PIERGIORGIO BERUTO
ANTONIO ORZELLI

IEEE 802.3cg
PLCA CRS usage
August 29th, 2018

current draft 2.0

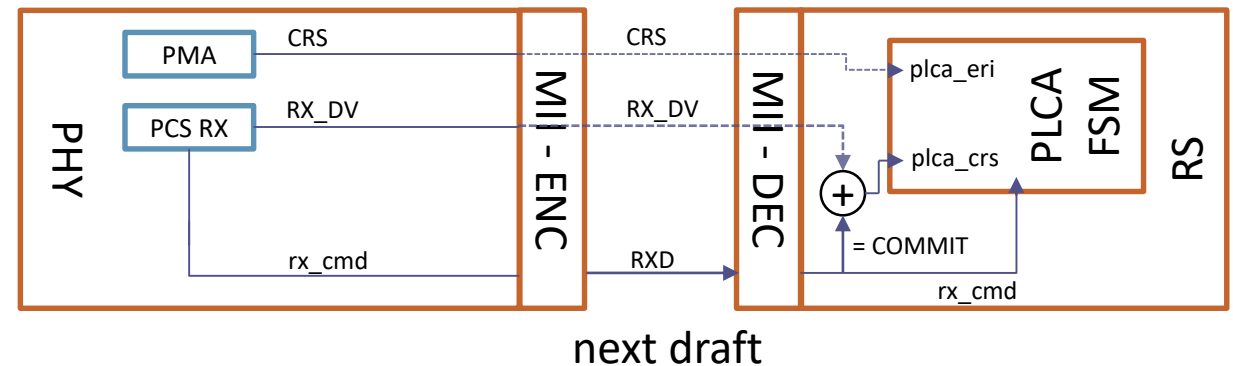
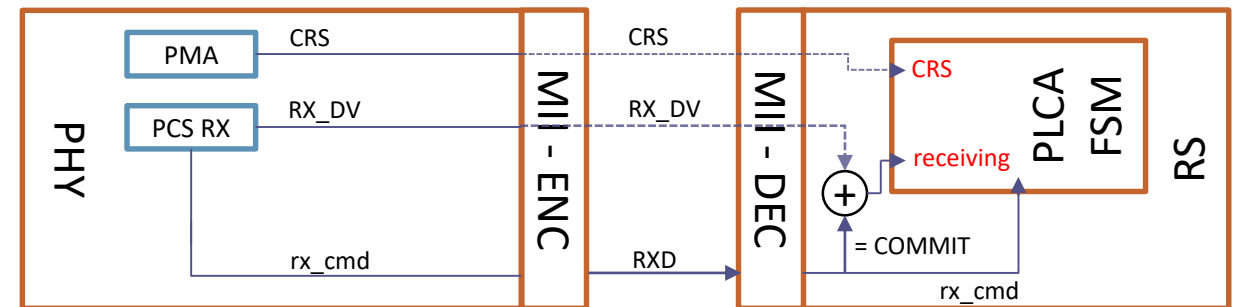
- 10BASE-T1S PHY generates CRS as the logical OR of 'transmitting' and 'receiving' PCS variables
 - asserted when a COMMIT or packet preamble is detected
- According to comment #649 this way of generating CRS, although used in other standards (e.g. 100BASE-X), is not suitable for an half-duplex multidrop PHY
 - CRS should be generated based on energy detection instead

- PLCA RS logically relies on two information from the PHY
 - `plca_eri` (Early Receive Indication)
 - Asserted when the PHY detects activity on the line
 - `plca_crs`
 - Asserted when a COMMIT or valid packet is being decoded from the line
- These two information are encoded on MII signals and conveyed to PLCA
 - COMMIT and BEACON are also conveyed via MII, encoded on RXD and decoded to `rx_cmd`
- CRS generation has an impact on PLCA

- CRS generation does not change at all the way PLCA works
 - the information PLCA needs is still available, it just need to be encoded differently
- This can be done with a simple variable substitution
 - $plca_eri \leftarrow CRS$
 - CRS being asserted on energy detection is ERI by definition!
 - $plca_crs \leftarrow RX_DV + (rx_cmd = COMMIT)$
 - $plca_crs$ can be deduced from RX_DV (valid packet) or when receiving a COMMIT, by definition

$plca_eri$ is now generated from CRS directly

$plca_crs$ is now decoded in the RS from RX_DV and rx_cmd

- plca_eri renamed to “CRS”, to avoid confusion
- plca_crs renamed to “receiving” to avoid confusion
- Proposed text changes can be found in the following documents, marked with #649
 - http://www.ieee802.org/3/cg/public/Sept2018/beruto_04_Cl_148_d2p0_proposed.pdf
 - http://www.ieee802.org/3/cg/public/Sept2018/beruto_03_Cl_147_d2p0_proposed.pdf
 - http://www.ieee802.org/3/cg/public/Sept2018/beruto_01_Cl_22_d2p0_proposed.pdf
